HISTORIC AND DESIGN REVIEW COMMISSION

HDRC CASE NO: 2021-026
COMMON NAME: Unaddressed lot to the immediate south of 334 Burleson, on N Mesquite
ADDRESS: 334 BURLESON ST
LEGAL DESCRIPTION: NCB 519 BLK 24 LOT E 42 FT OF N 134.09 FT OF 8
ZONING: IDZ-1, H
CITY COUNCIL DIST.: 2
DISTRICT: Dignowity Hill Historic District
APPLICANT: cesar sosa/5 ELEMENTS INTERNATIONAL LLC
OWNER: Ruben Lara/5 ELEMENTS INTERNATIONAL LLC
TYPE OF WORK: Construction of two, 2-story residential structures
APPLICATION RECEIVED: February 04, 2021
60-DAY REVIEW: Not applicable due to City Council Emergency Orders
CASE MANAGER: Edward Hall

Historic and Design Review Commission
Design Review Committee Report

PROJECT NO. S-363
CONSTRUCTION DOCUMENTS
10 SEPTEMBER 2020

1 ENLARGED SITE PLAN
SCALE: 1/8" = 1'-0"

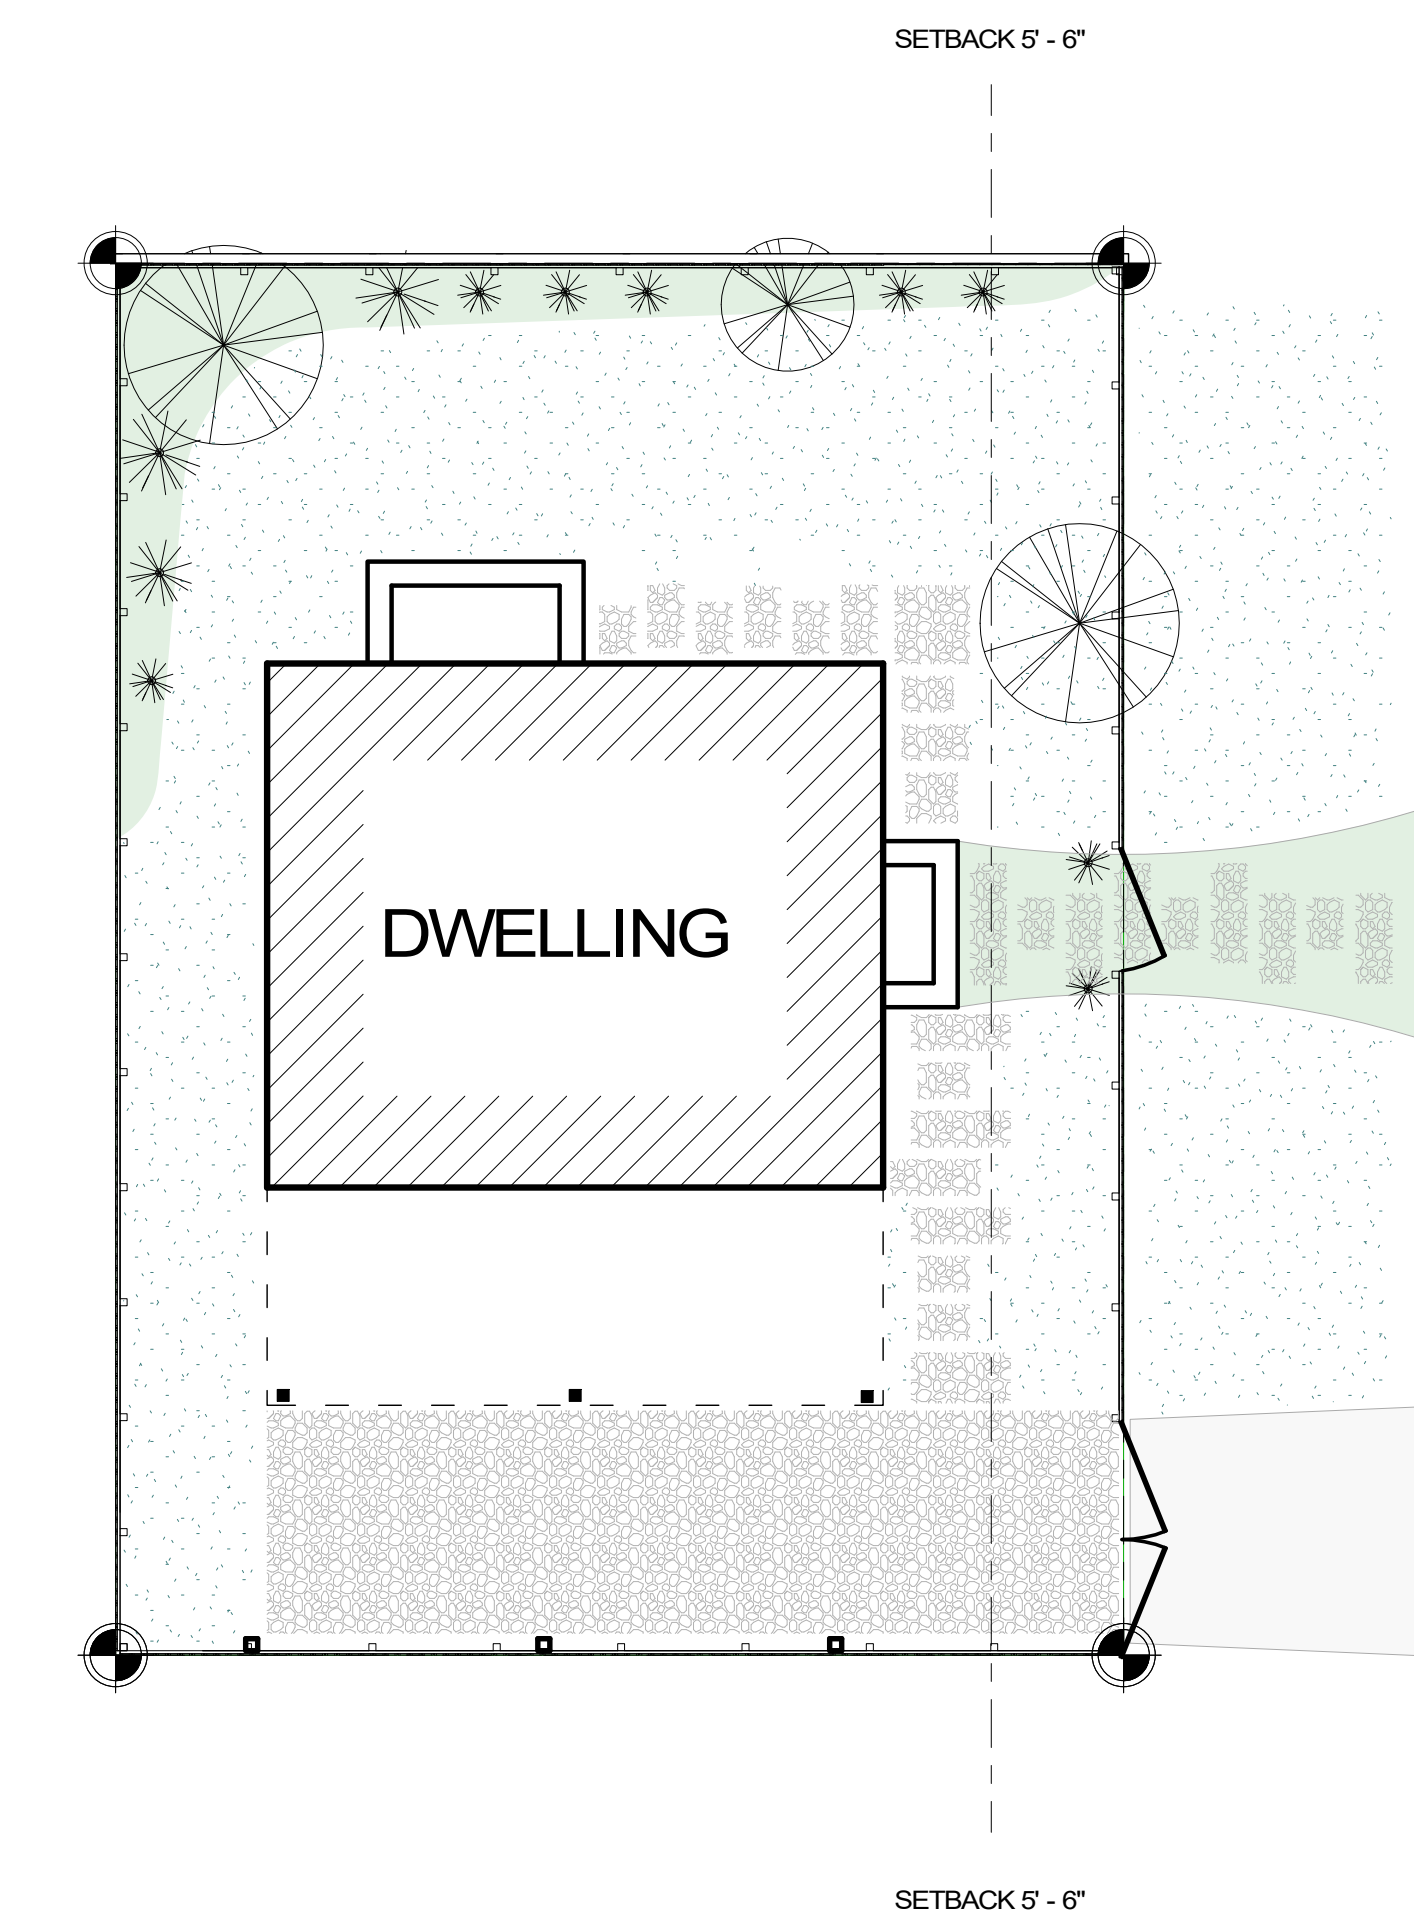
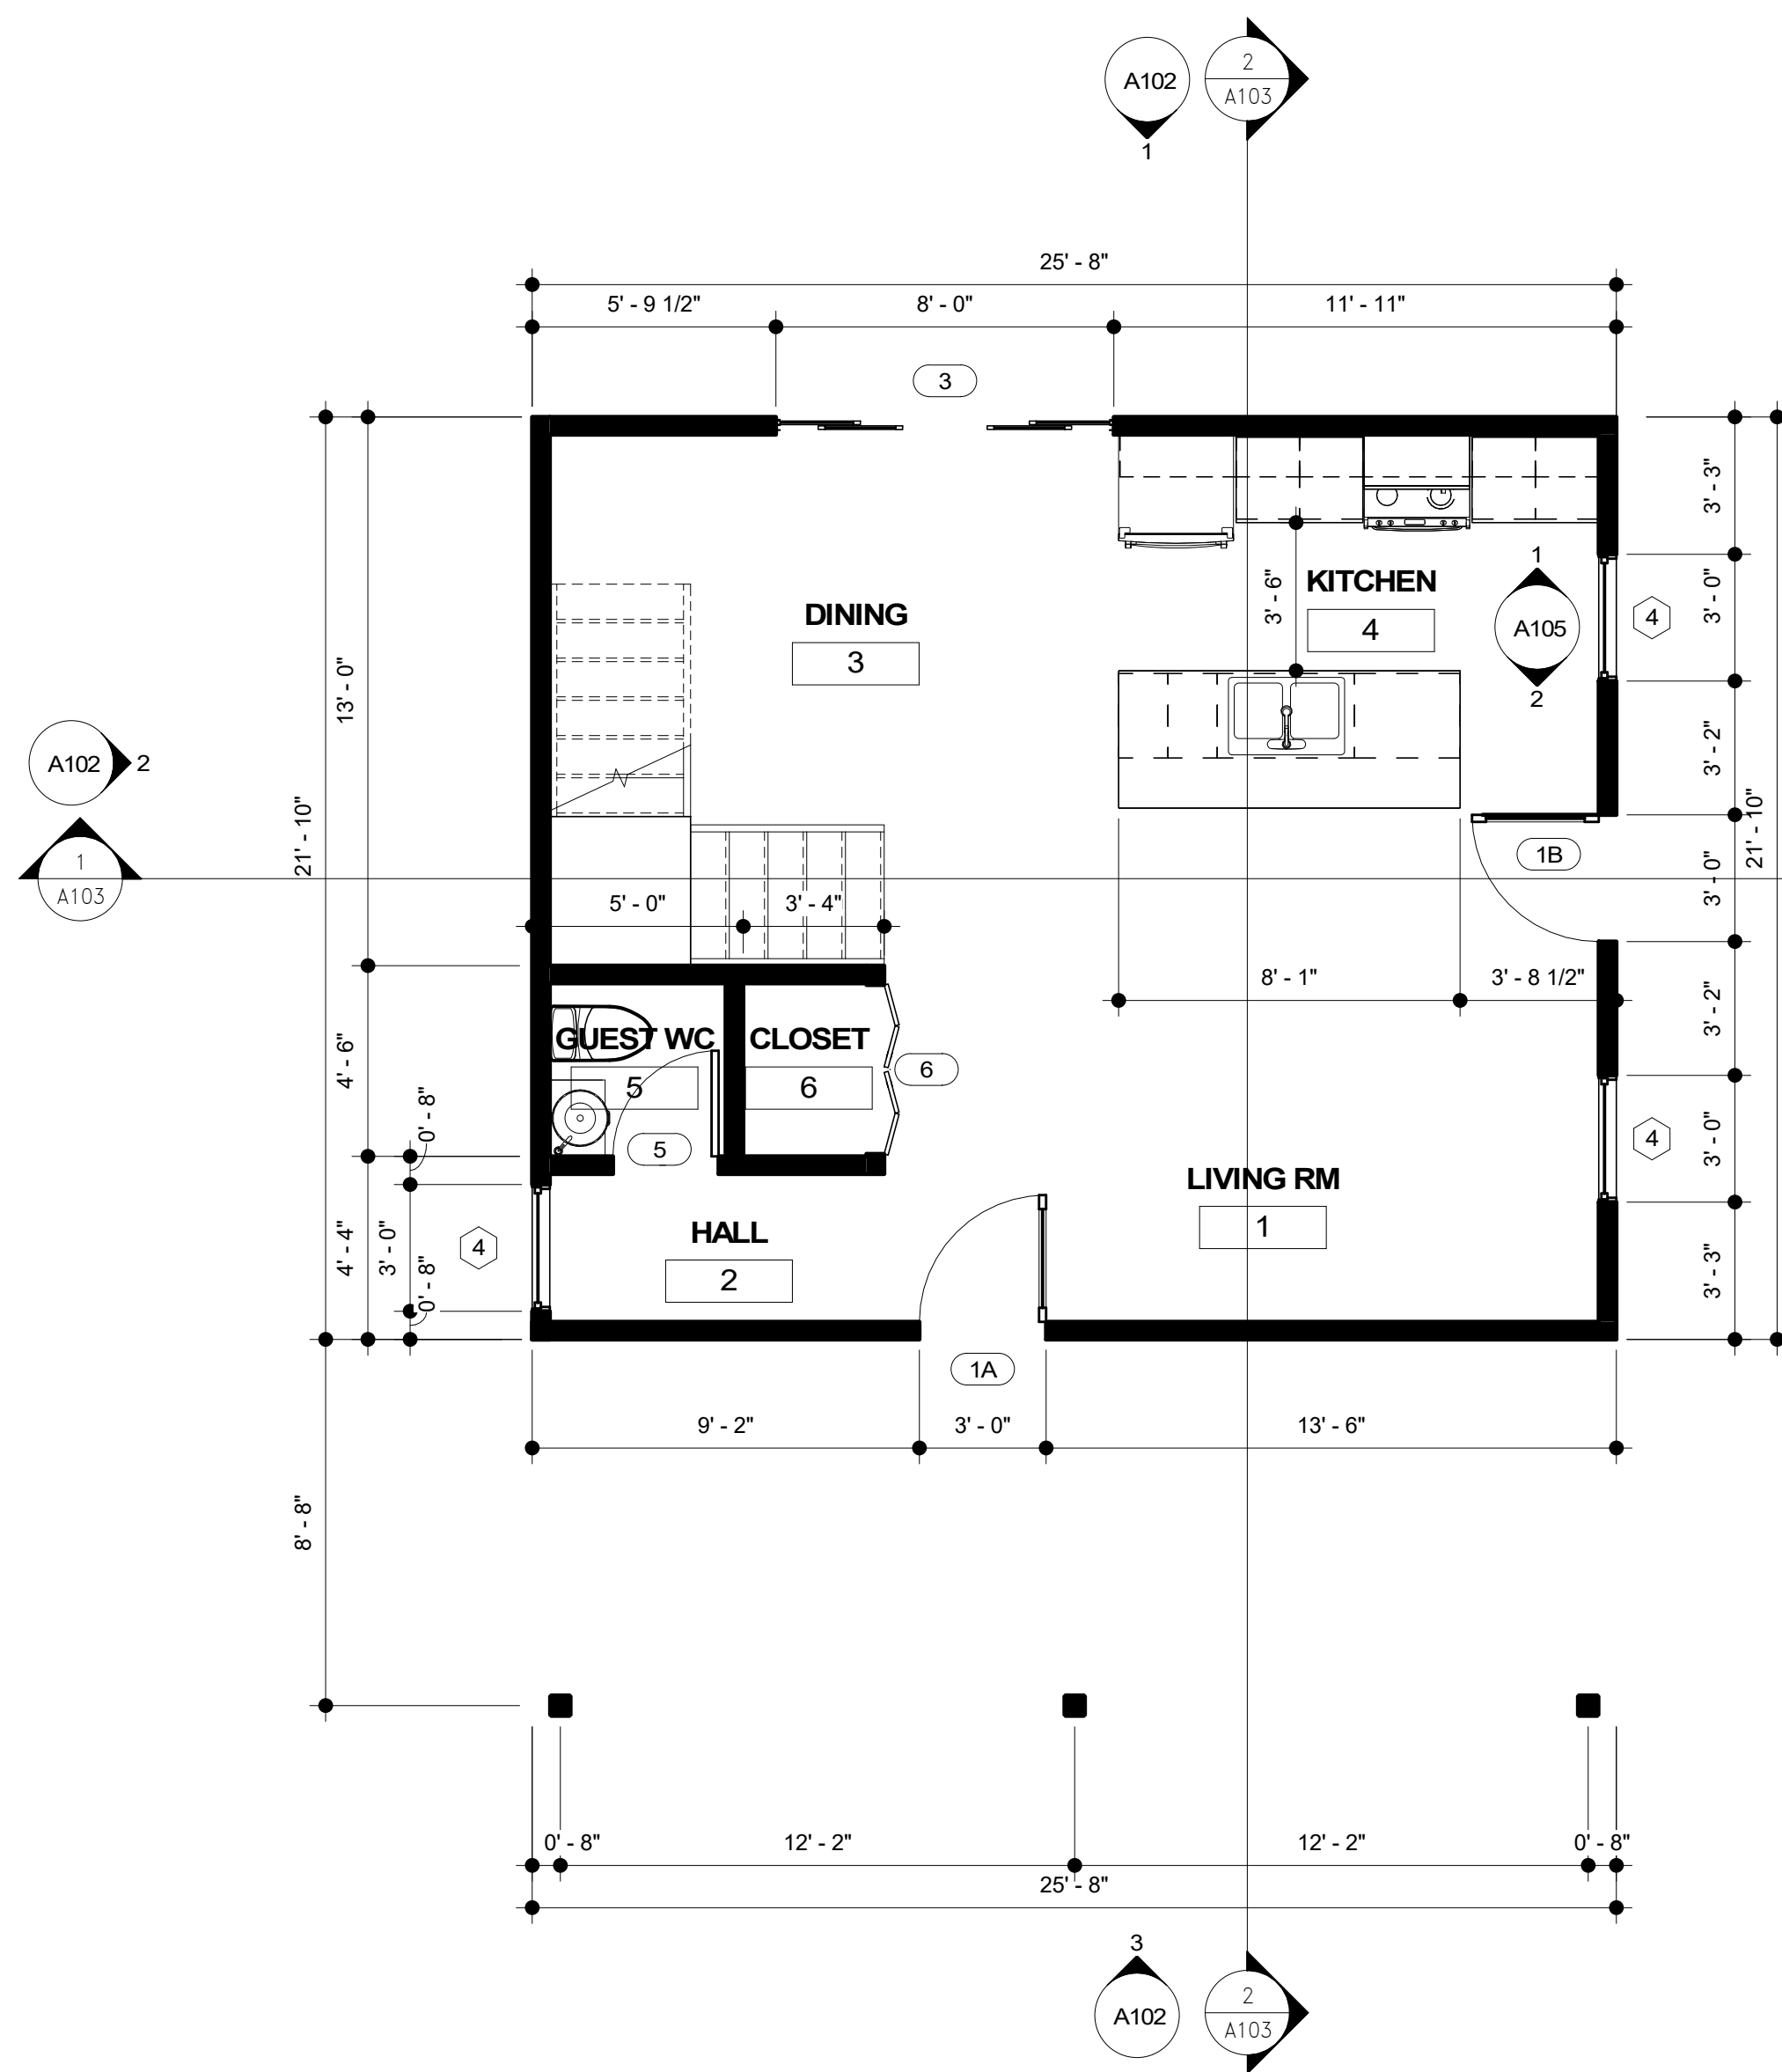
- 2a. SETBACKS – The applicant has proposed a setback of ten (10) feet from the right of way to be greater than that of the historic structure at 919 N Mesquite. Generally, staff finds the proposed setback to be appropriate.

- 2j. DRIVEWAY – The applicant has proposed a driveway to the south of the proposed new construction. Staff finds the proposed driveway location to be appropriate; however, the driveway should not exceed ten (10) feet in width.

- 2k. PARKING – The applicant has proposed parking to be located beneath a cantilevered mass of the primary structure. Generally, parking within or beneath the footprint of the primary structure is not found historically

- 2l. FENCING – The applicant has proposed fencing around the perimeter of the lot, including a driveway gate at the right of way. Staff finds that if a driveway gate is proposed, it should be behind the front façade of the primary structure as this is the pattern found historically within the district.

- 2m. WALKWAY – The applicant has proposed two walkways, one leading to the right of way on N Mesquite and the other leading to the proposed driveway. Staff finds that the proposed walkway leading to the right of way on N Mesquite should be consistent with the Guidelines for Site Elements, and feature a continuous concrete profile.

- i. That the applicant increase the proposed setback to be greater than those found historically on N Mesquite, as noted in finding 2a.
 - ii. That the applicant reduce the proposed massing to be consistent with the Guidelines, as noted in finding 1b.

- viii. That the proposed driveway not exceed ten (10) feet, that continuous concrete sidewalk be installed to connect to the right of way on N Mesquite, and that a detailed landscaping plan is submitted noting landscaping materials and the location of screened mechanical equipment.
